This addendum to the original design and access statement seeks to identify the adjustments to that statement that are required as a consequence of the revisions to the approved scheme and to demonstrate how the scheme has been developed to maintain the spirit of the original design intent.

Typical Guest floor plan

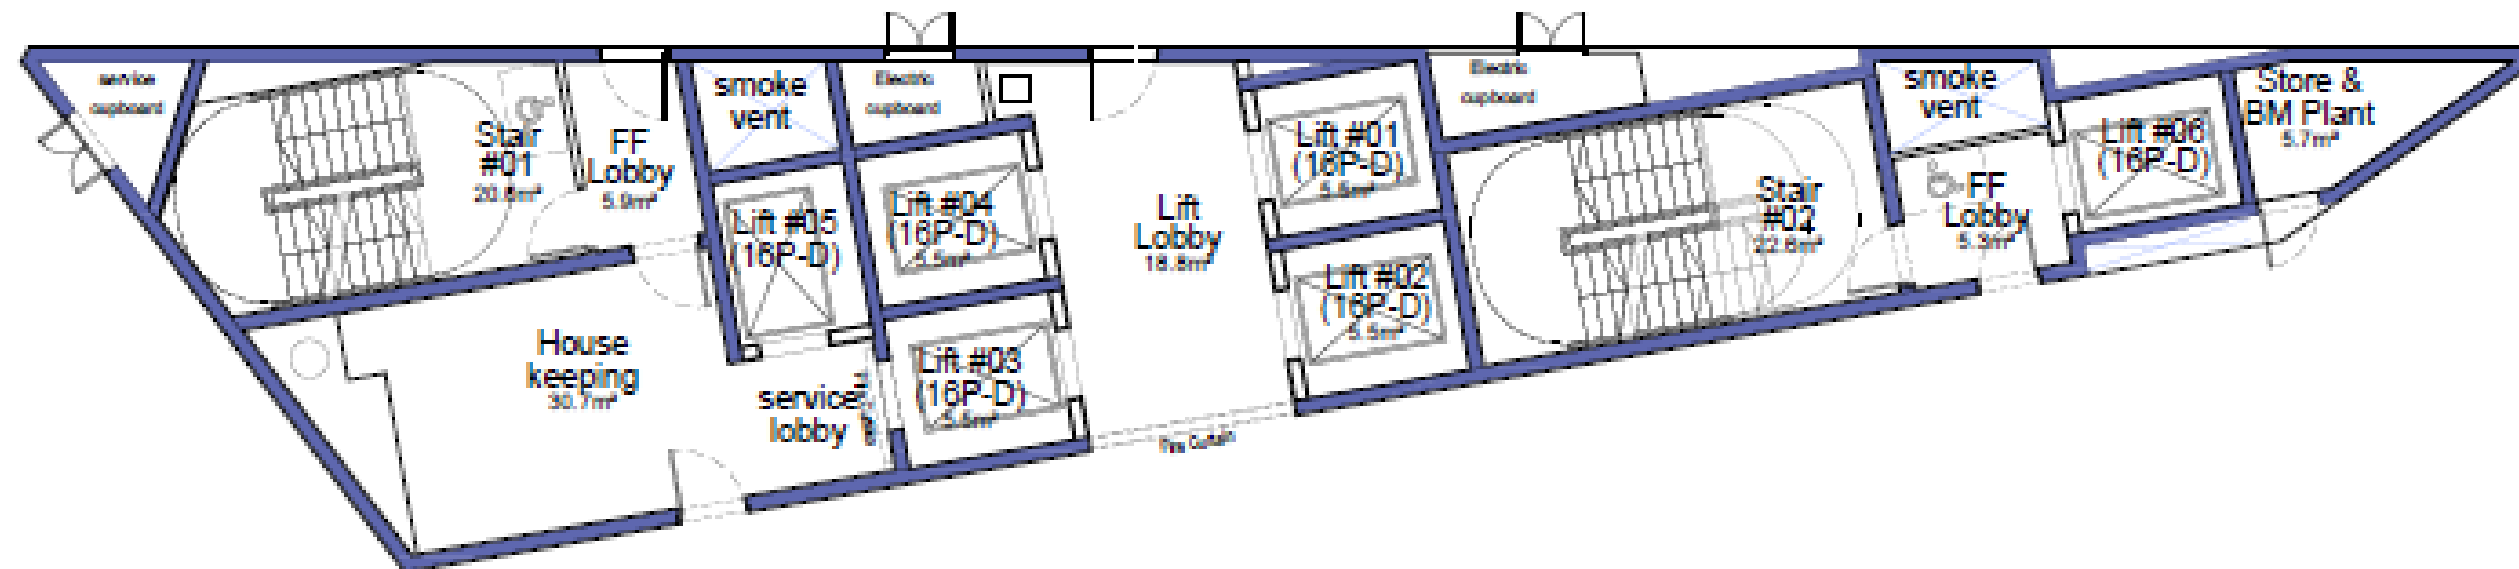
The benefit of the re-planning and structural solution for the core of the building has resulted in us being able to gain an additional 1 no bedroom on each standard bedroom floor. The hotel brand (Hilton Garden Inn) standard bedroom is now planned although it should be noted that each bedroom is approximately 1.3sqm smaller than the brand standard.

“Non- standard” bedrooms are formed in the 4 corners of the floor plate and other spaces within the unusual lozenge plan form are used for housing building services and Back of House operations.

Typical core plan

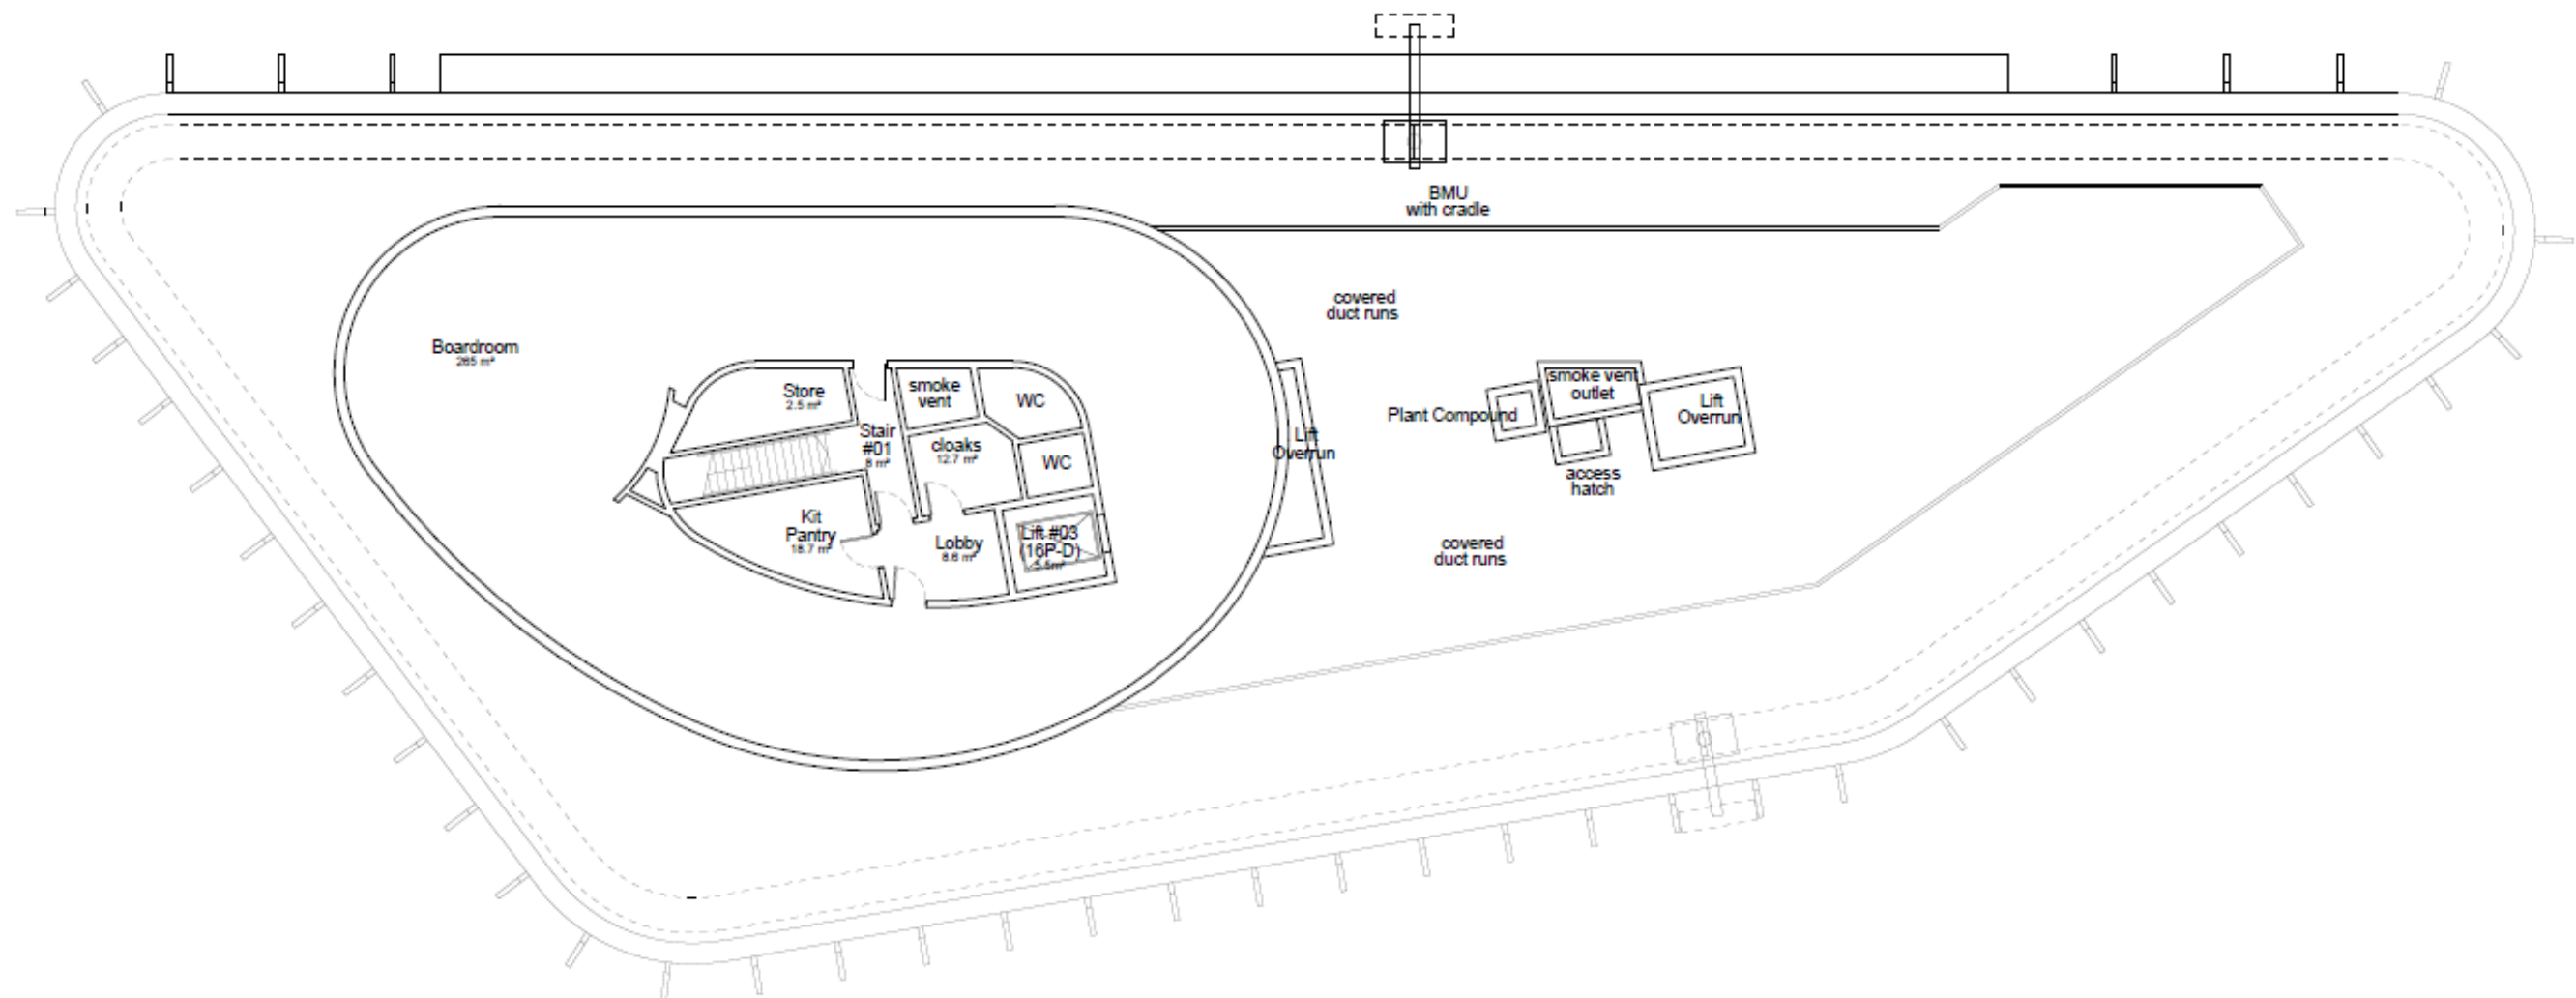
The core comprises 6 no. lifts (4 guests, 1 service lift and 1 fire-fighting lift), 2 no. staircases, housekeeping, service risers and smoke ventilation for stair fire-fighting lobbies.

The walls enclosing this principal core and several cross walls are the main structural skeleton of the hotel providing stability.

14th floor plan

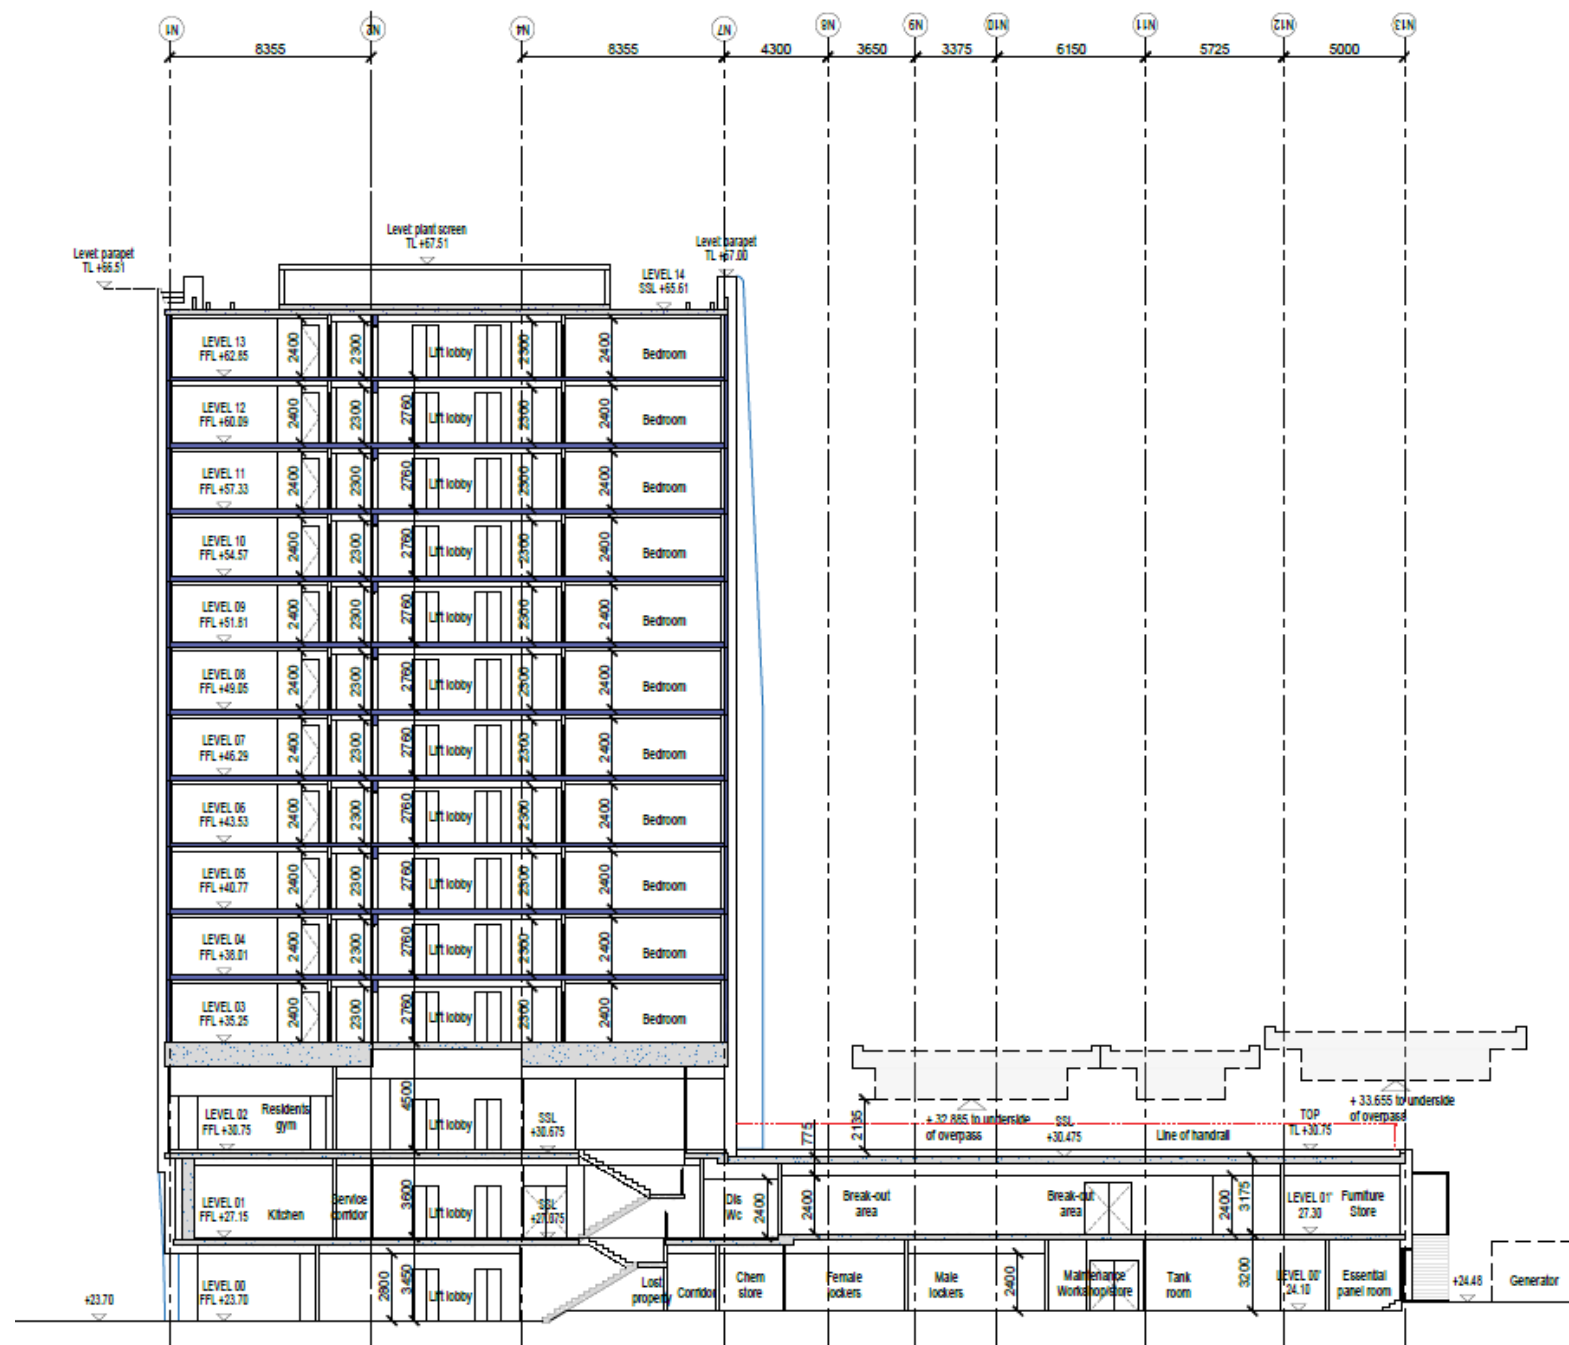
The proposals now incorporate a boardroom at roof level as an adjunct to the meeting suite.

It is intended that this will offer a unique facility with unparalleled views of the airport. Access will be via dedicated guest lift by use of electronic key cards allowing access to this level only. The number using this facility will be within the available capacity of the escape stairs.

Typical building cross section

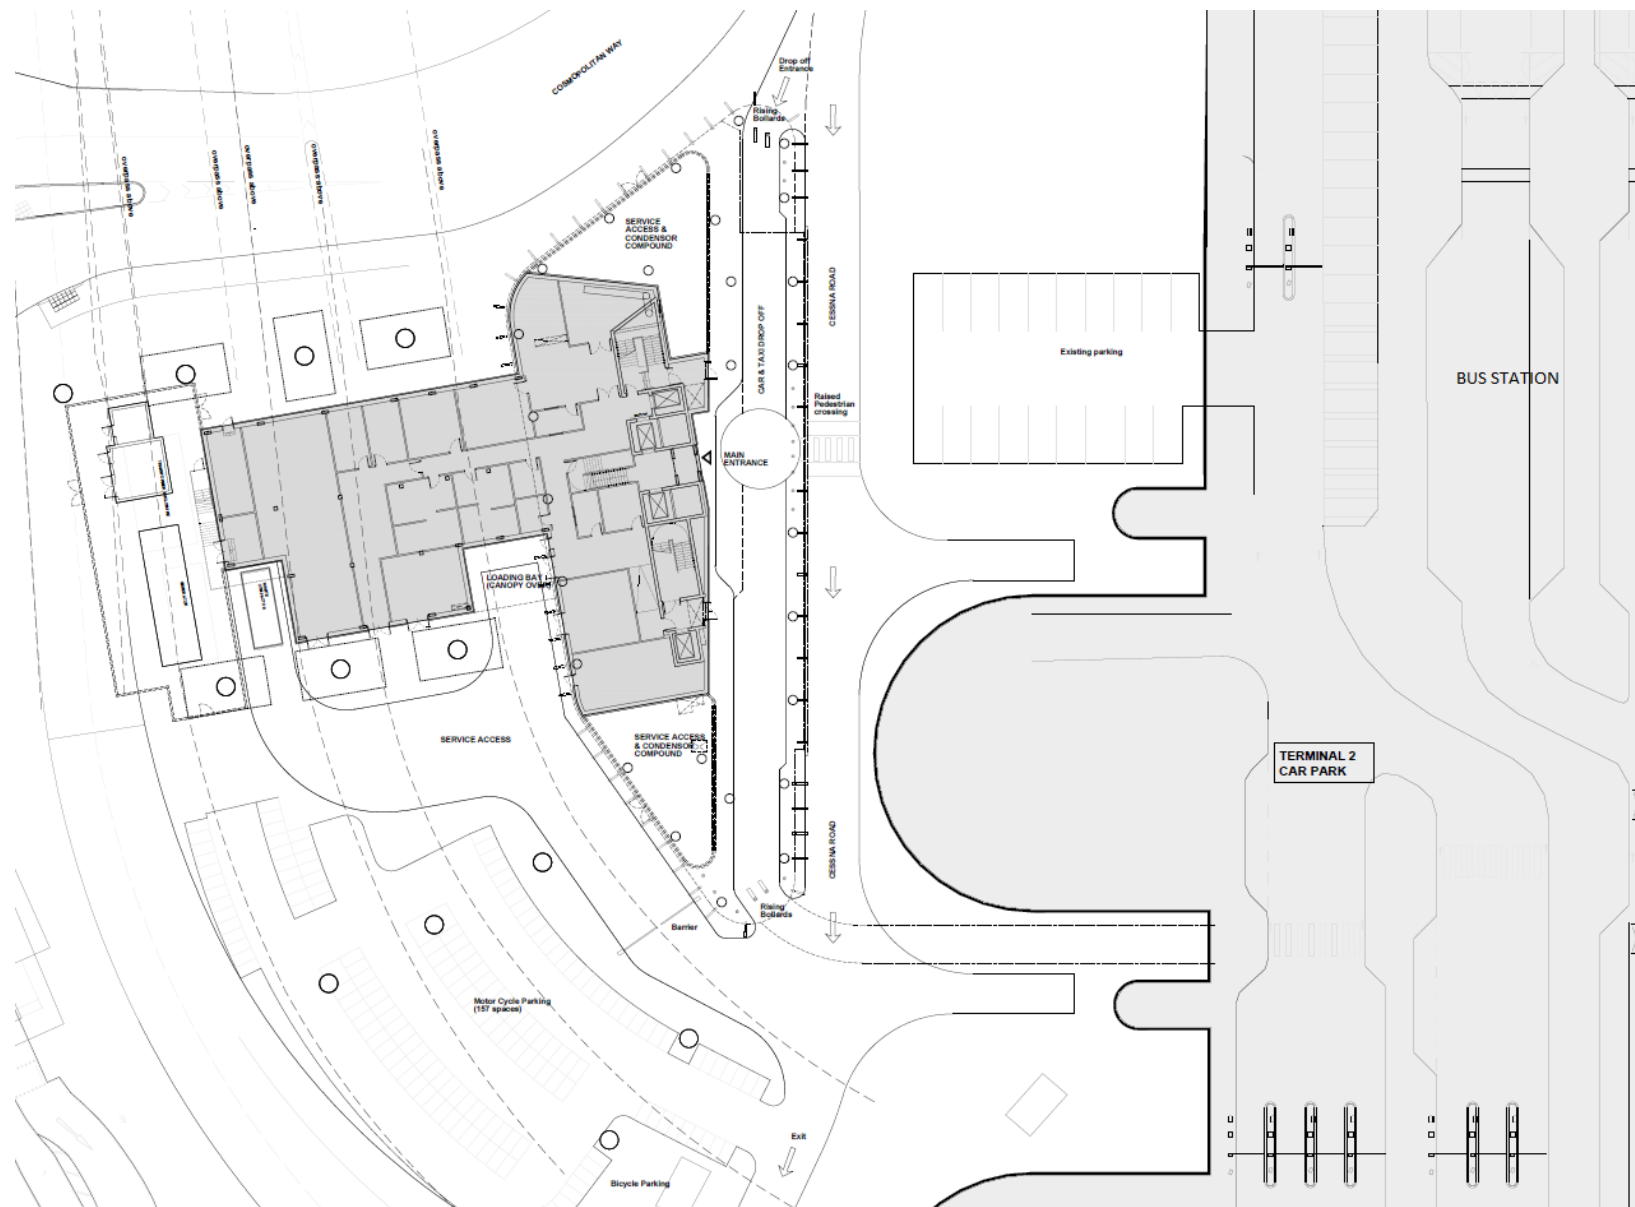
As part of the review of the approved design, and in the course of re-stacking the building section, it became evident that it would be possible to rationalise the section and achieve a more efficient use of the volume.

Consequently, by rationalising the floor to floor heights on the guest floors and with the re-structuring of the public areas onto 3 floors at the lower levels it was possible to introduce an additional floor of guest rooms and yet still maintain the level of the roof as that of the approved scheme.

It is noted that the proposed addition of the boardroom exceeds the approved height but given that the configuration of this sits well back from the façade, the perception of the building mass from the ground remains as per the approved scheme.

Ground floor plan showing retained services

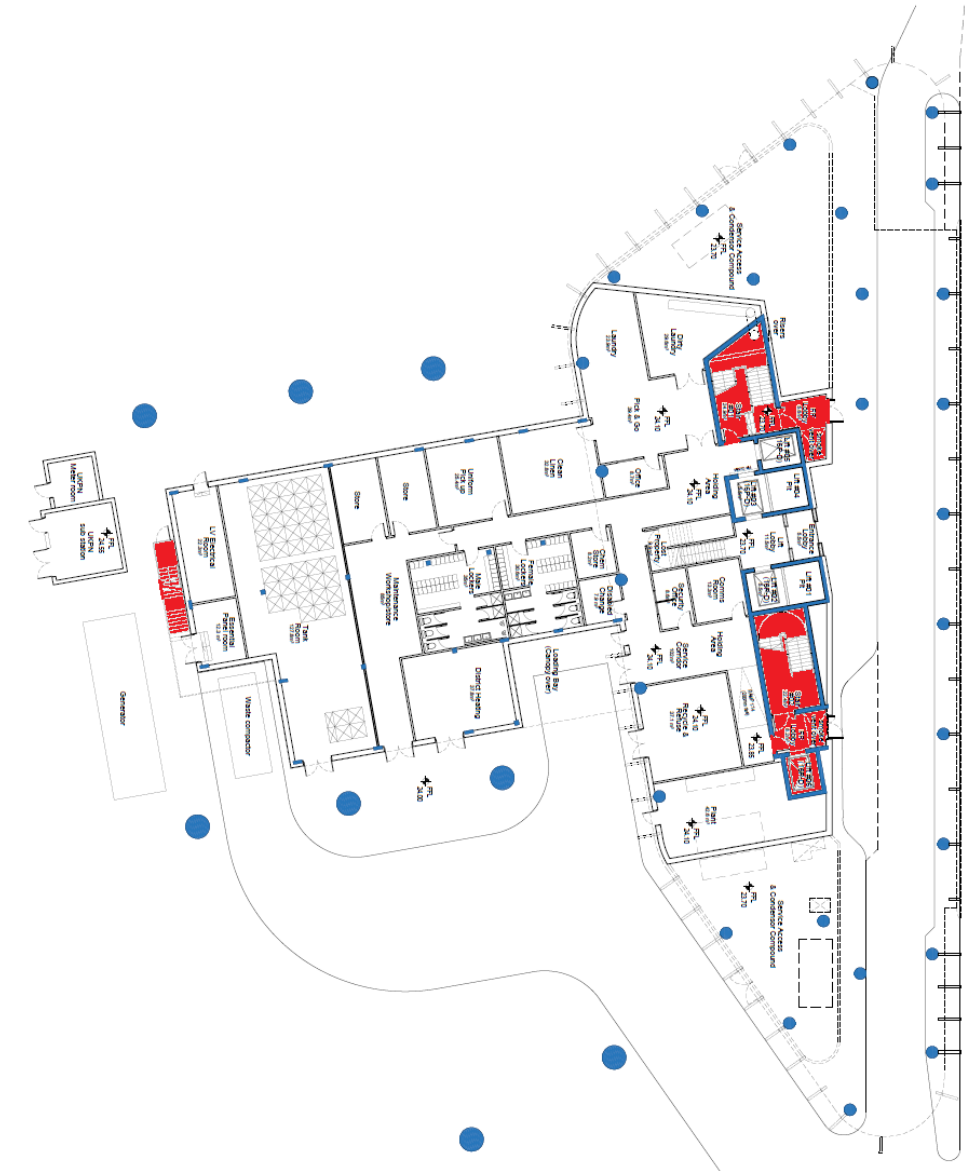
Structural stability of the building has been a challenge due to the limited number of piles which can be achieved within a relatively small building footprint in comparison to the building height.

This is further complicated because the pile and ground beam / pad foundations had to be designed around a number of “essential” Heathrow services underneath the building footprint.

A number of these services could not be diverted and so the foundations “dance” around them.

The solution included moving both stairs and all lifts into the central core area. This simplified the grounding of the lifts and stairs, thereby cleaning up the vehicle drop off at ground floor level.
